Our Ref: 21-05/001100  
DSC Ref: MCUC 2021/4008-1  
Date: 30 April 2021

**RE: RESPONSE TO INFORMATION REQUEST IN RELATION TO AN APPLICATION FOR MATERIAL CHANGE OF USE FOR MULTIPLE DWELLINGS AND SHORT-TERM ACCOMMODATION AT 8 DAVIDSON STREET, PORT DOUGLAS**

# Annexure 1: Revised Drawing Set

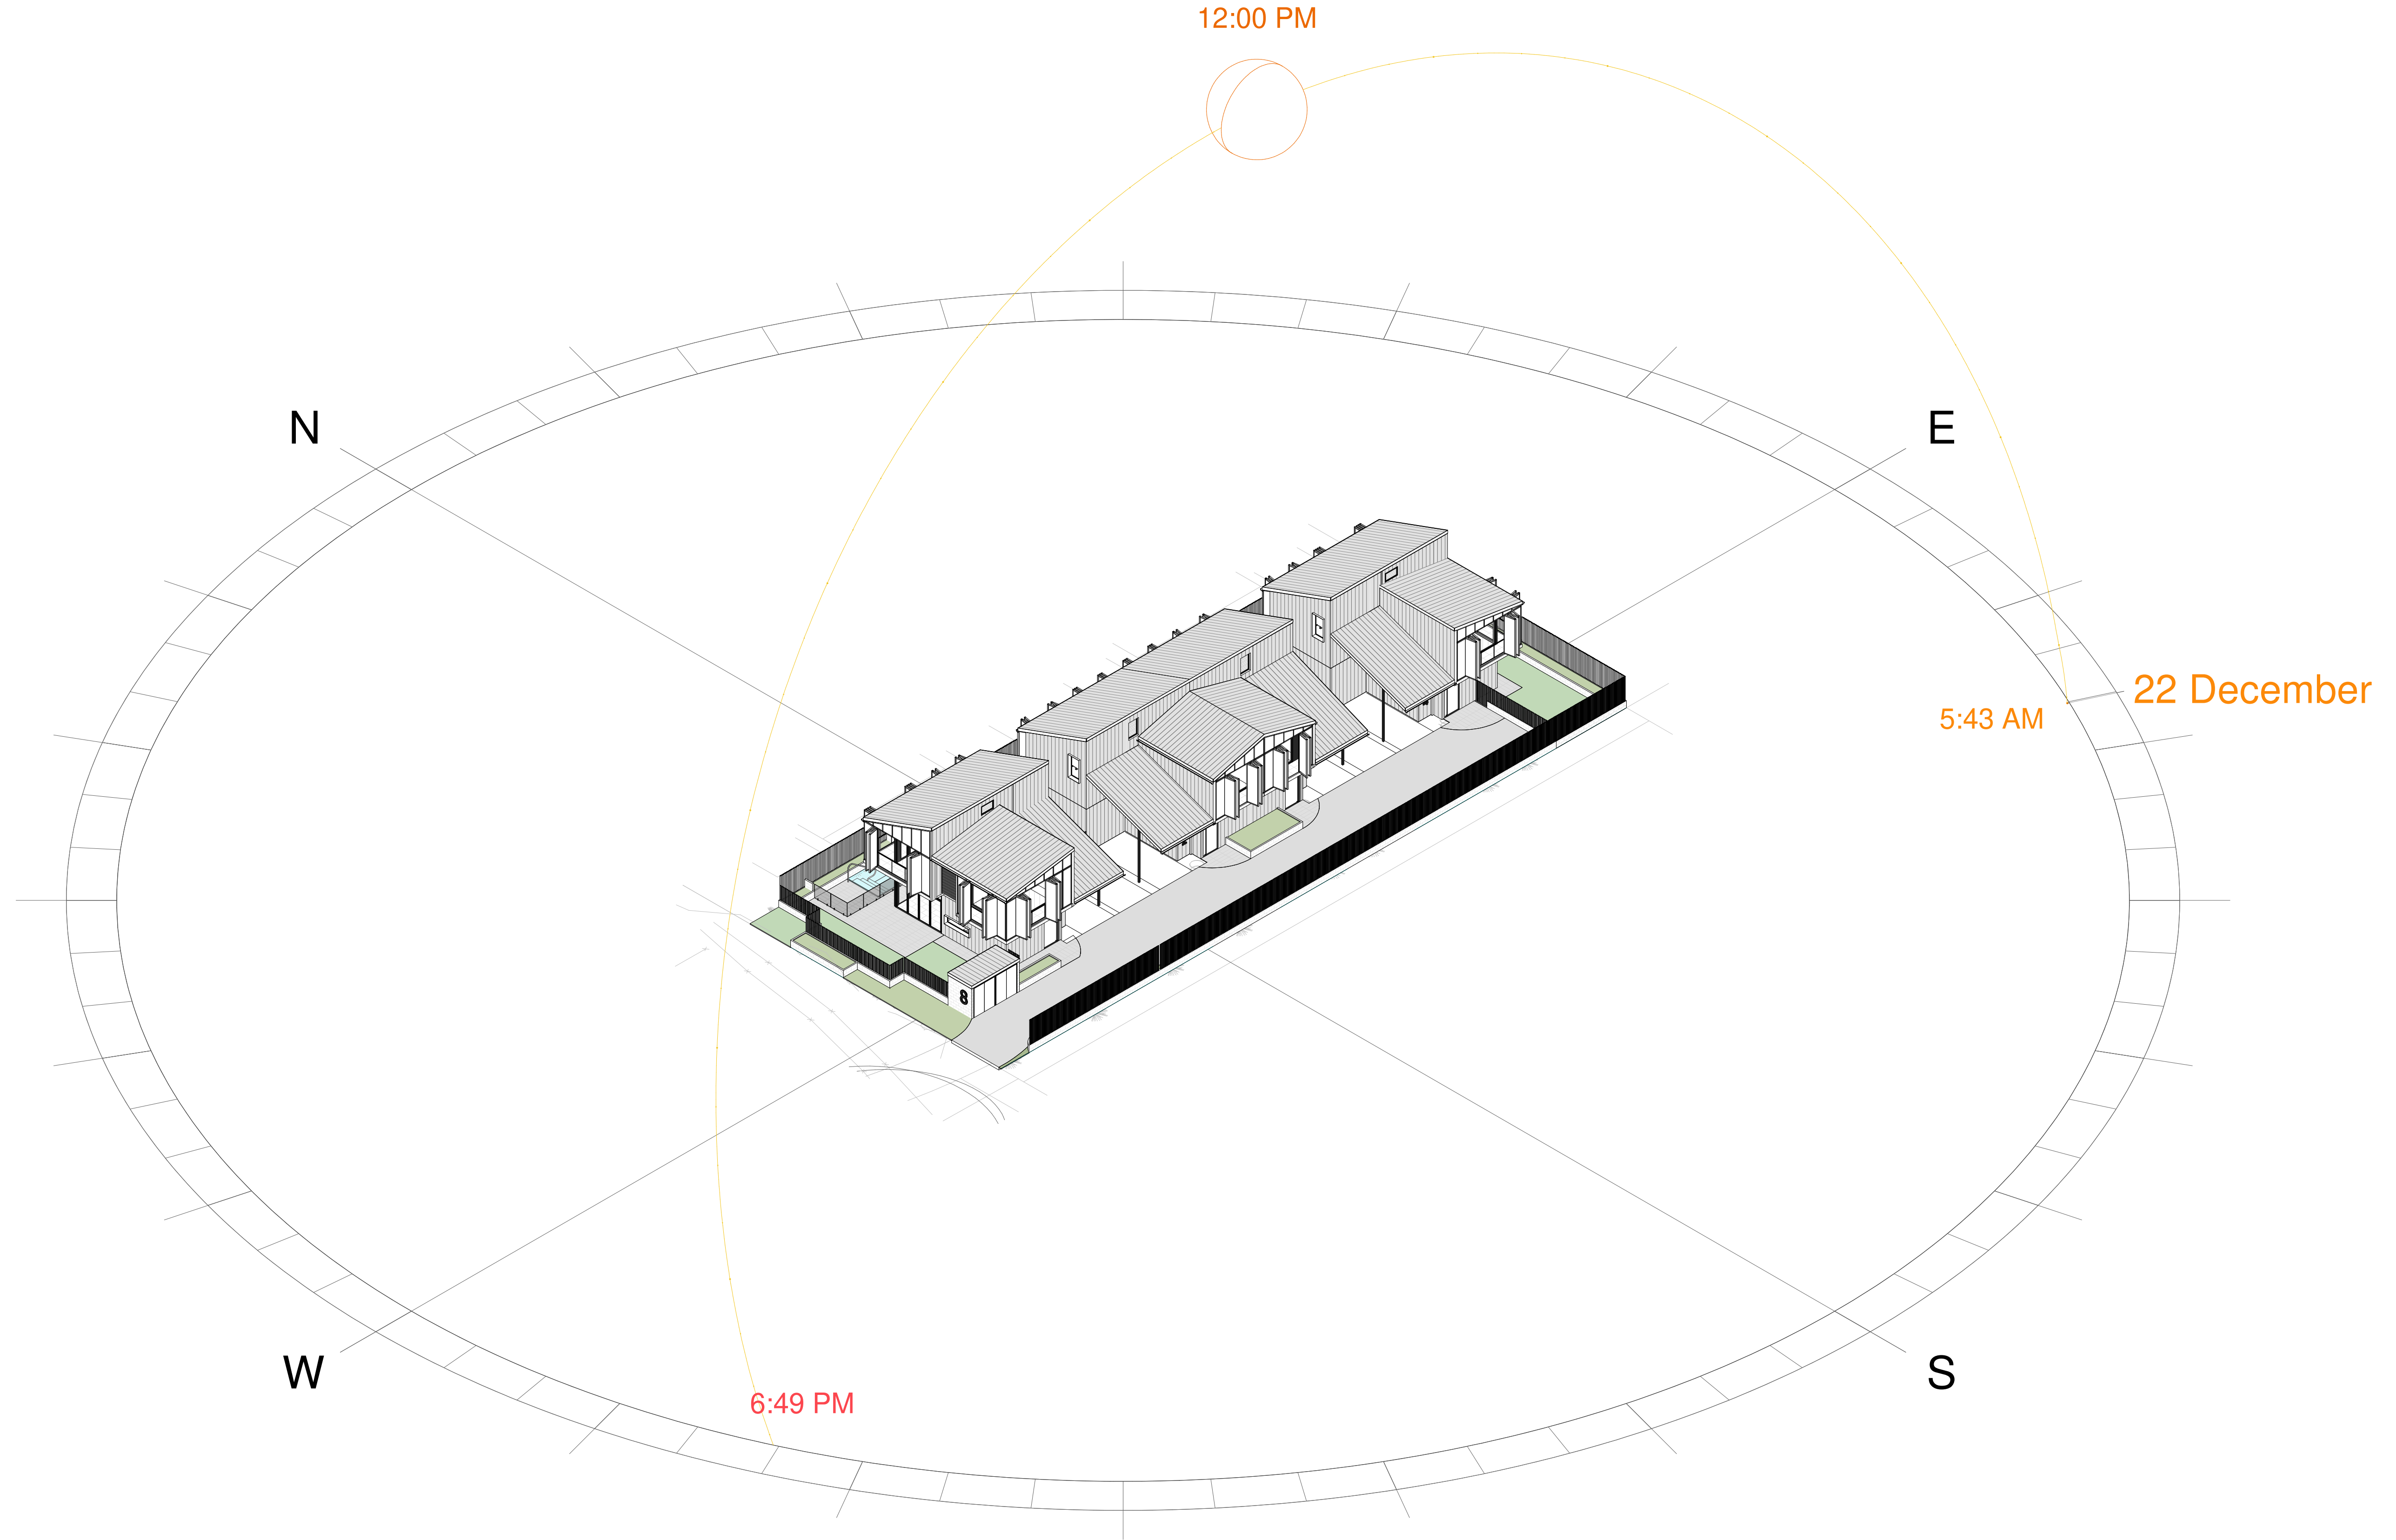
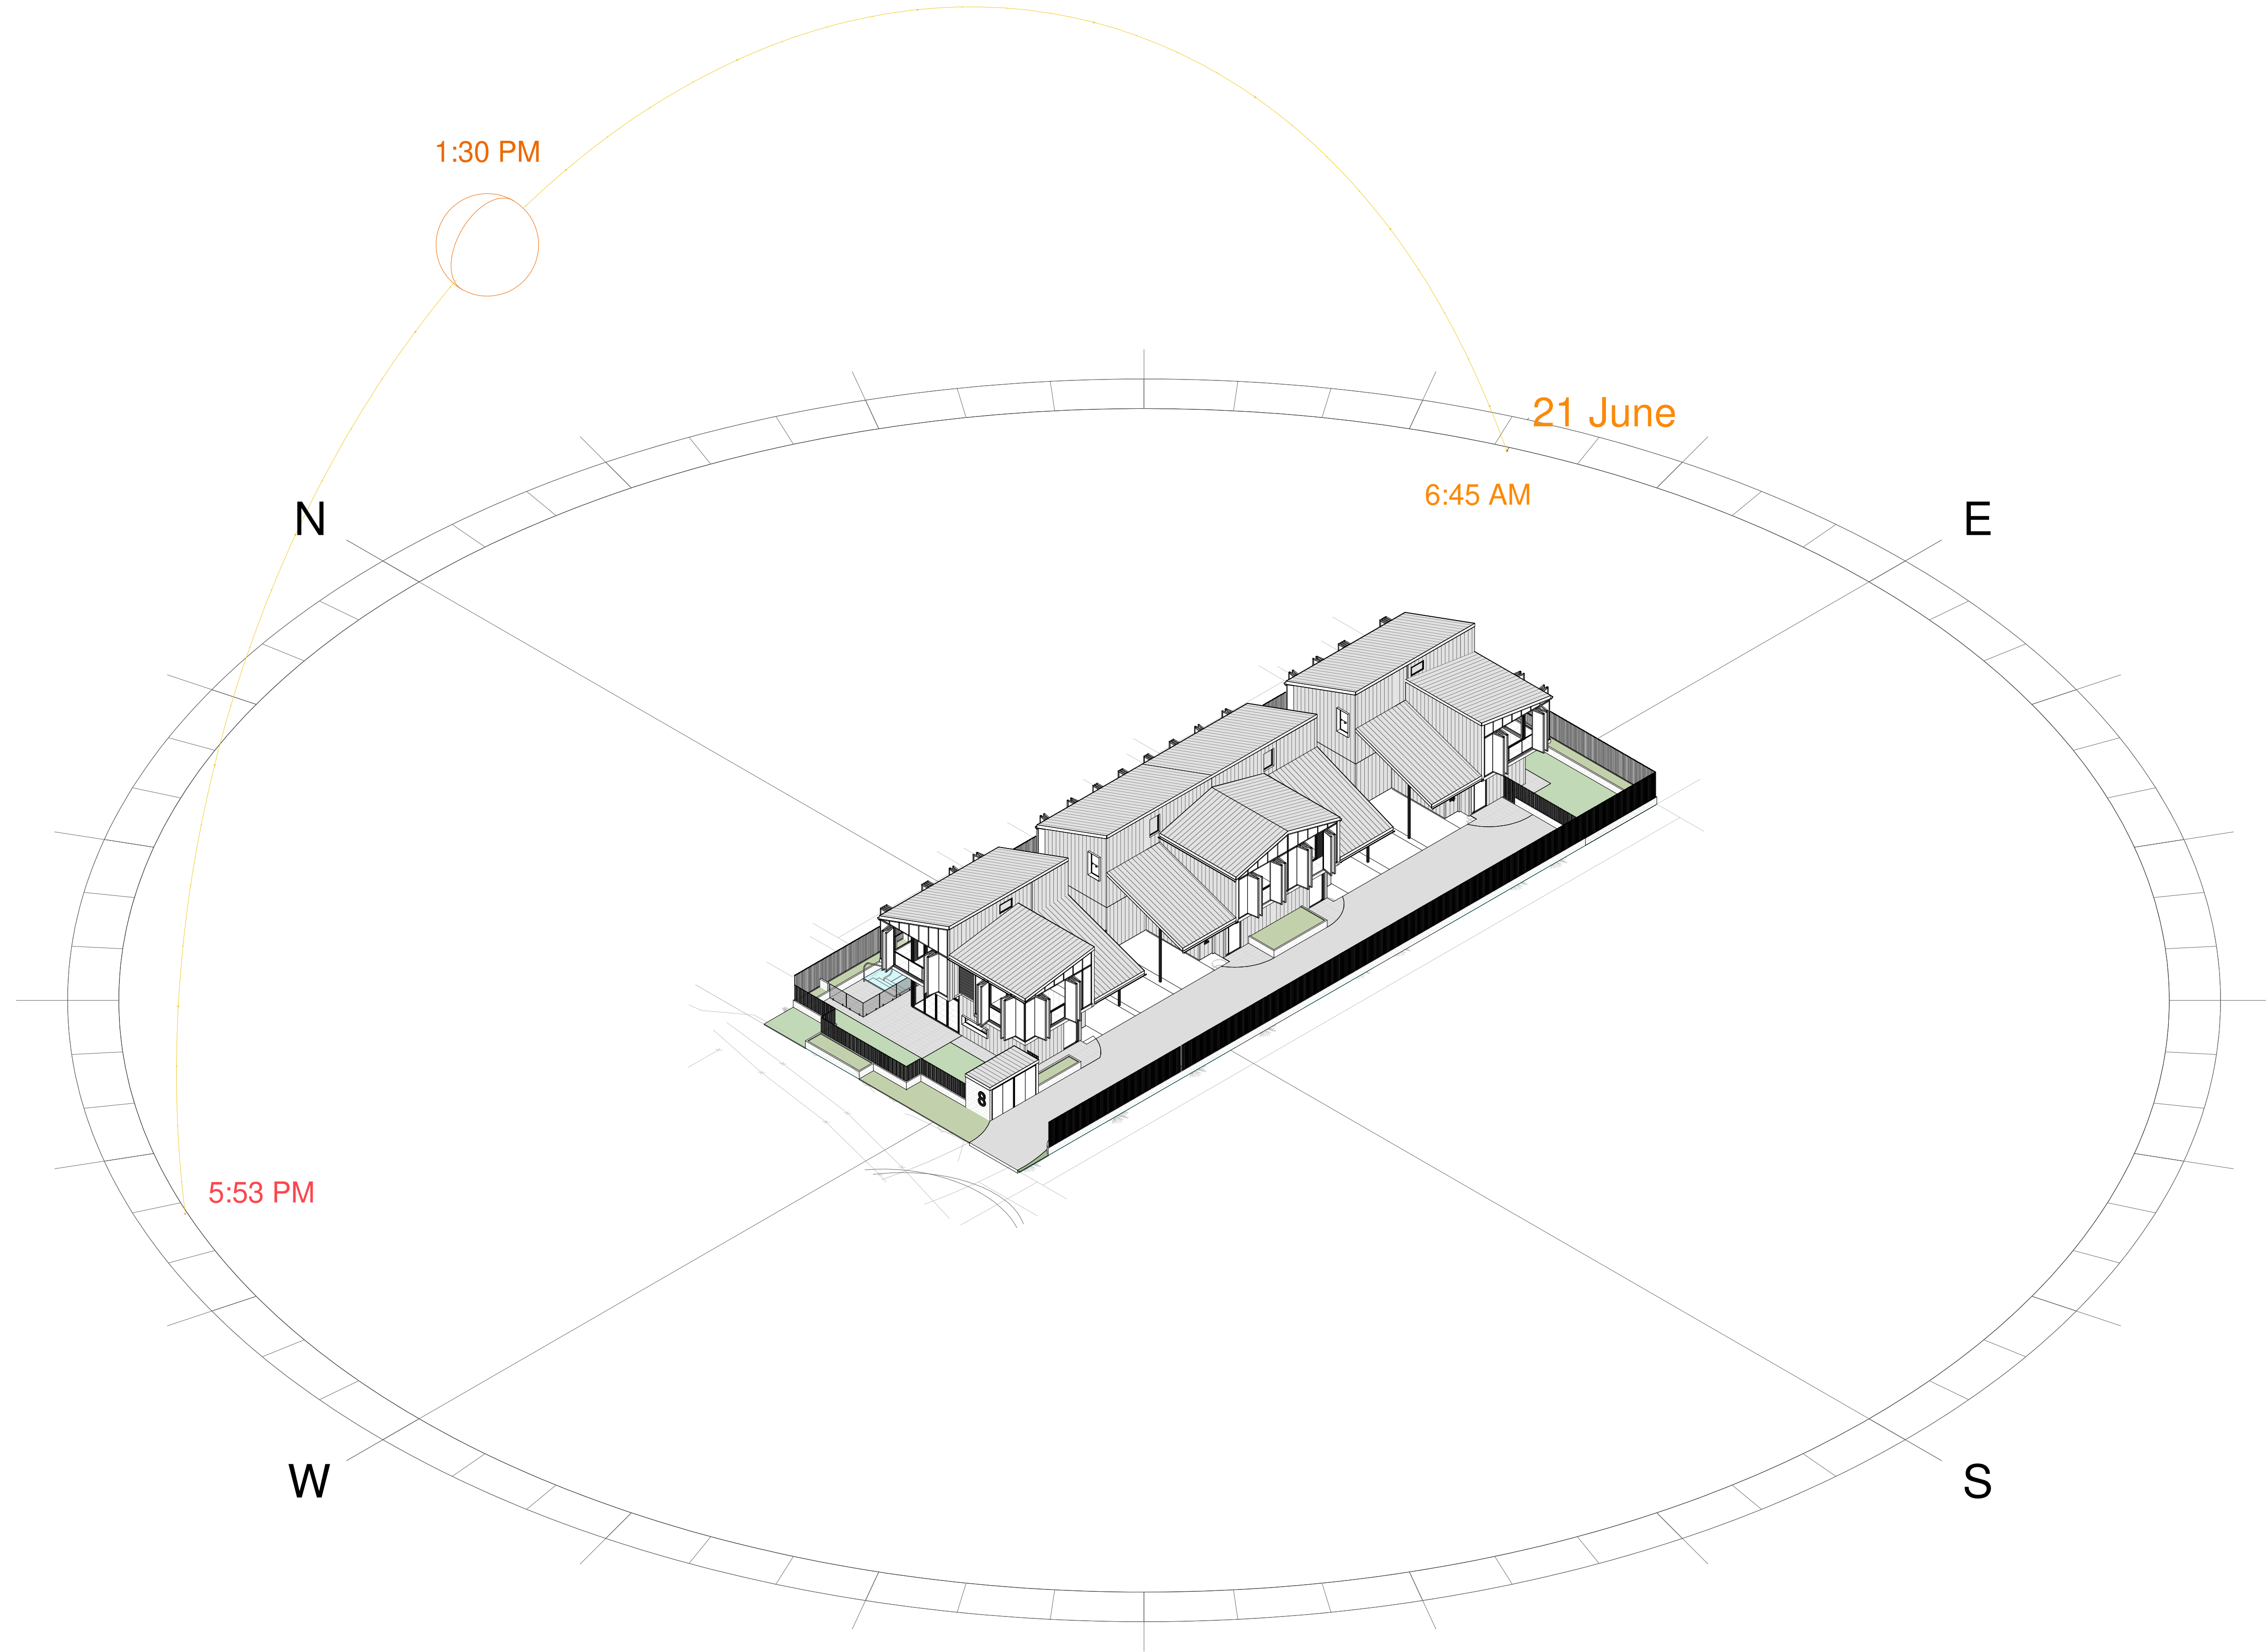
- 1. Please clarify the measurement by detailing this dimension on plan of the building setback from all boundaries. The setback of the first floor should also be nominated.***

Please see updated drawing set included as **Annexure 1** which details setback dimensions.

1 Elevation North  
TP210 Scale 1 : 100

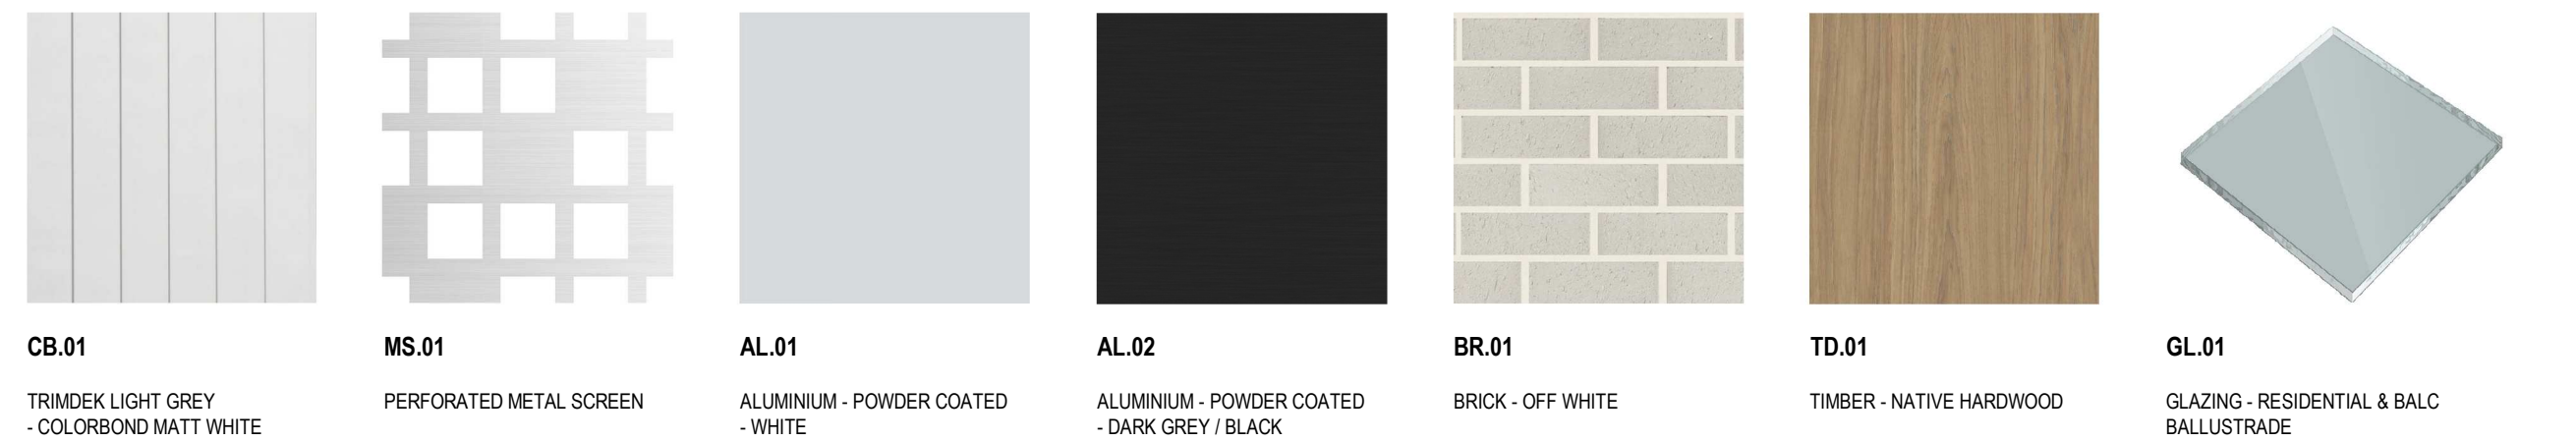
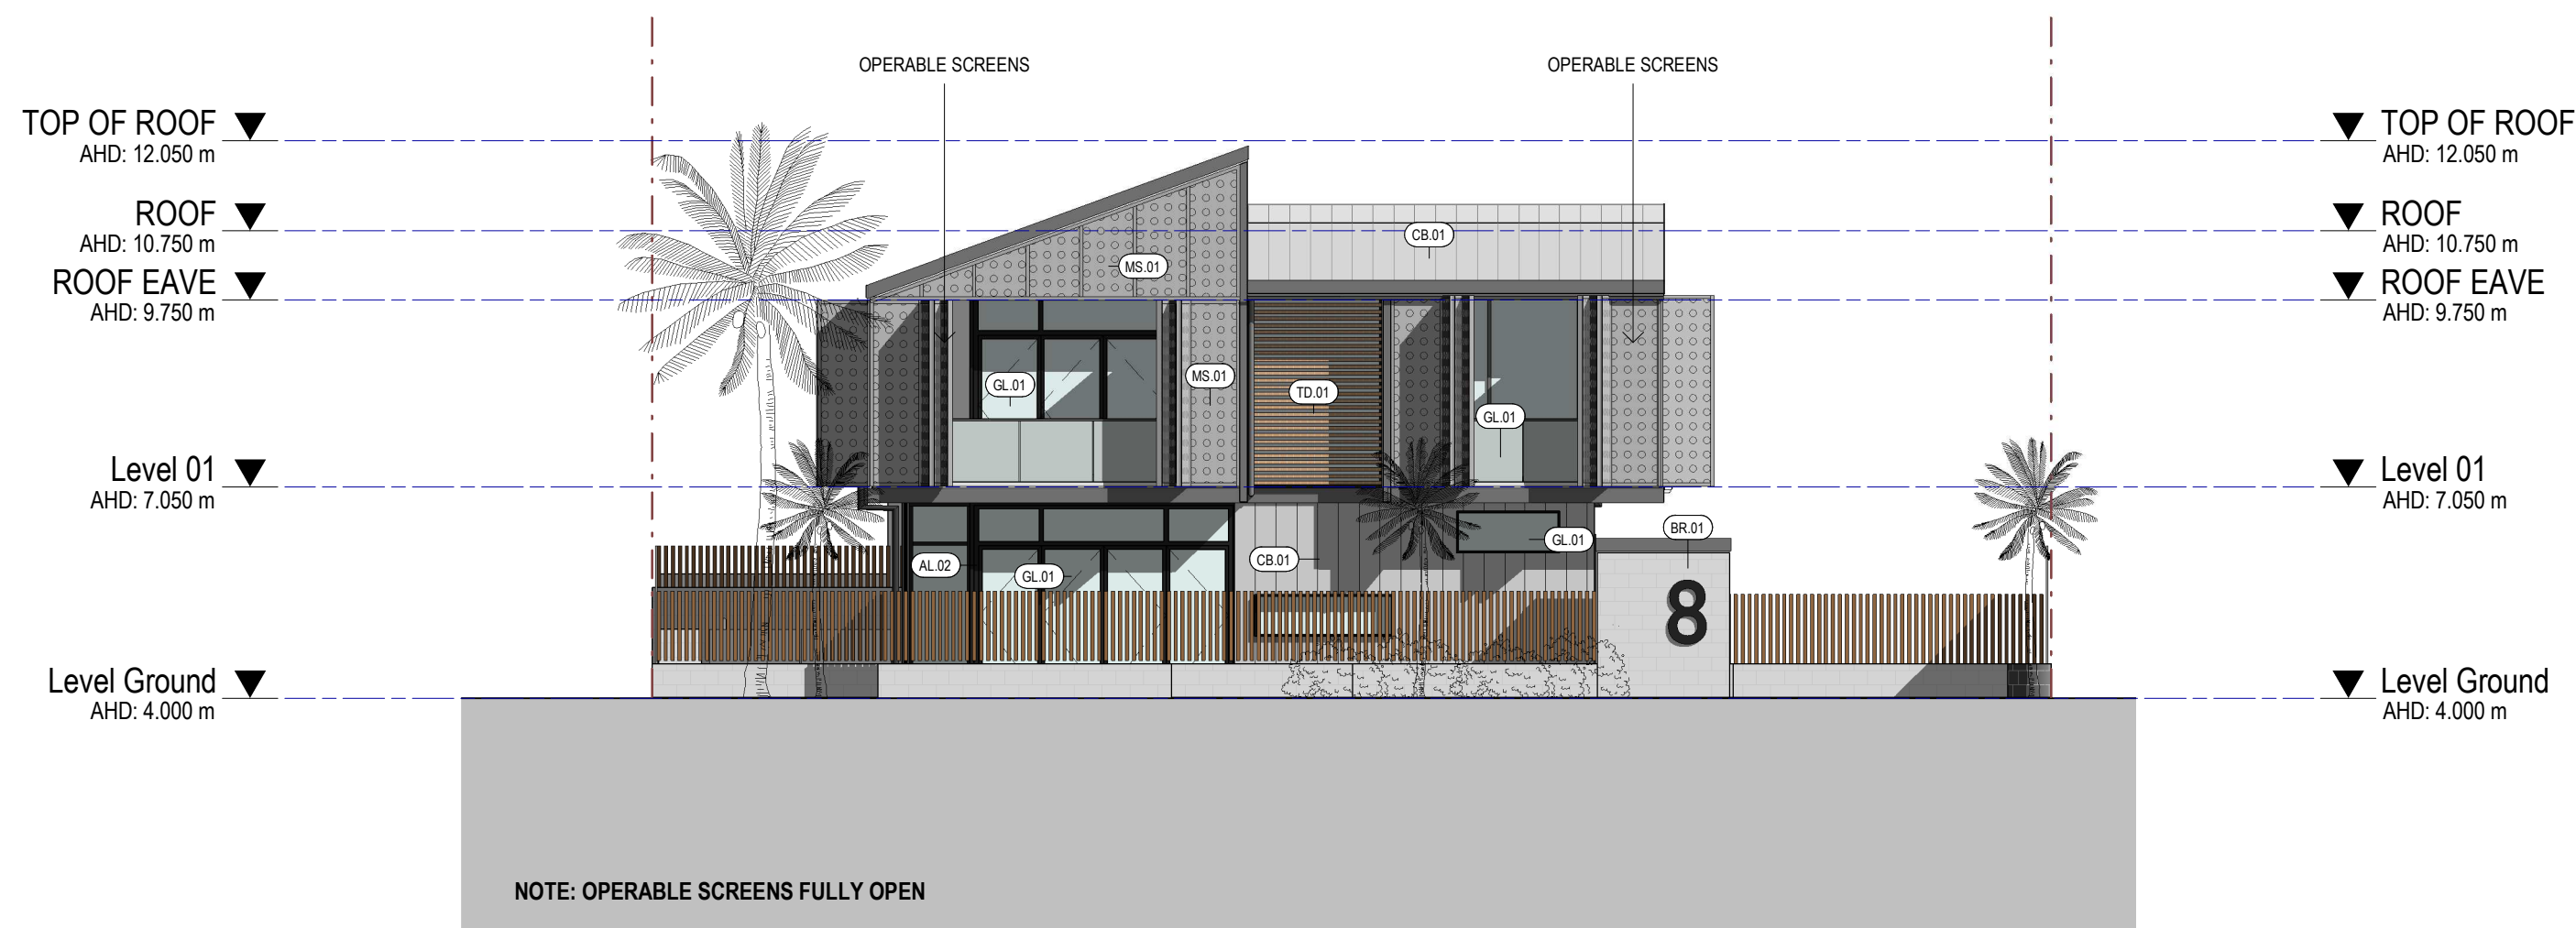
- 2. Please clarify the materials and finish of the first floor screens and whether these screens are moveable or fixed.***

Please see the elevations within the revised drawing set included as **Annexure 1** which detail the proposed finishes and identify that the screens are in fact moveable.
